Project Title
 North Irish Sea Array Offshore Windfarm

Drawing Title
 Grid Facility Proposed Drainage Layout Sheet 2 of 2

Role	Civil
Suitability	A2 - APPROVED FOR PLANNING
Arup Job No	281240
Name	281240-ARP-ONS-GF-DR-CD-1201
Rev	C02

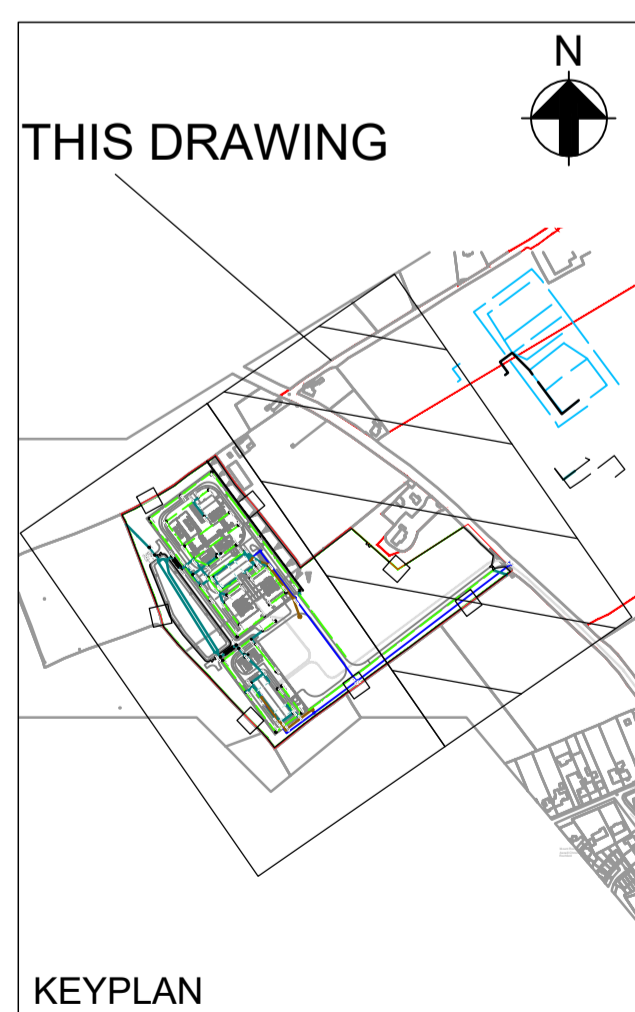
THIS DRAWING HAS BEEN UPDATED TO REFLECT THE REVISED LANDSCAPE MANAGEMENT PLAN WHICH HAS BEEN PREPARED IN COMPLIANCE WITH RFI SECTION 13 (E). AS PART OF THIS PLAN, THE DRAINAGE SYSTEM REQUIRED AN UPDATE FROM STORMWATER SWALES TO FILTER DRAINS AND THE PALISADE FENCE TO A CONCRETE POST-AND-RAIL FENCE.
